Response to Office Action Mailed November 8, 2007

Tetsuji Ueno
10/553,064

FIG. 1

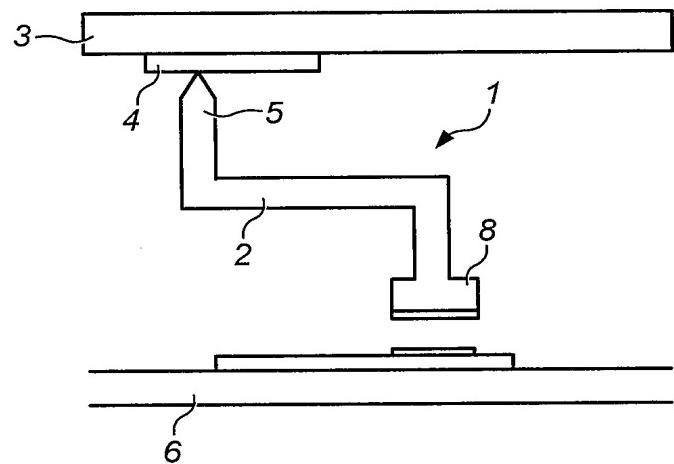
The contact part comprising an edge part having a tapered edge configuration wherein the edge part has a sectional configuration which shares at least one side face with the contact support part recited in claim 1 must be shown ...

Applicant submits that such features have been shown in the drawings. Referring to Figure 1, the depicted probe includes a supporting part 2 of the probe. Attached to probe supporting part 2, is contact part 5. An enlarged view of contact part 5 is depicted in Figure 2. As shown in Figure 2, contact part 5 includes a contact support part 10 and edge part 9. Edge part 9 has a tapered edge configuration, as shown in Figures 3 and 4. Edge part 9 shares at least one side face with contact support part 10, as shown in Figures 2, 3, and 4. Applicant submits that all of the features of the claims are depicted in the figures.

Referring to Figure 1, the depicted probe includes a supporting part 2 of the probe. Attached to probe supporting part 2, is contact part 5. An enlarged view of contact part 5 is depicted in Figure 2. As shown in Figure 2, contact part 5 includes a contact support part 10 and edge part 9. Edge part 9 has a tapered edge configuration, as shown in Figures 3 and 4. Edge part 9 shares at least one side face with contact support part 10, as shown in Figures 2, 3, and 4. Applicant submits that claim 1 is supported by the Figures and specification as filed.

Applicant's claims are directed to a modified probe. Turning to Fig. 1, a schematic of Applicant's probe is depicted. Probe includes a contact part (5) and a probe supporting part (2). Contact part (5) includes a contact support part (10, See Fig. 2) and an edge part (9). As can be seen in the figures, edge part (9) has a thickness that is less than the thickness of the contact support part.

FIG. 2

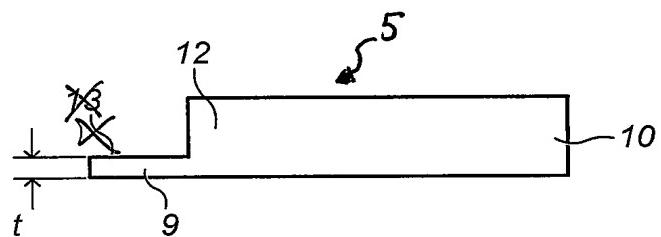
The Examiner indicated that different reference characters, specifically "9" and "13", are used to designate the edge part. For clarification, Applicant has amended the reference characters for the figures. Applicant has included a marked-up copy of the figures indicating the changes made and replacement sheets for the figures.

In contrast, Applicant's claims are directed to a contact part which includes an edge part and a contact support part. The edge part extends from the contact support part and has at least one side face that is shared with the contact support part. See for example, the side view representations depicted in Figure 2, the bottom part of Figure 3, and the left bottom part of Figure 4. Khoury does not appear to teach or suggest a contact part having this configuration, nor would it be obvious from the teachings of Khoury to modify the contact part described in Khoury to have the configuration described in Applicant;s claims and depicted in Figures 2, 3, and 4.
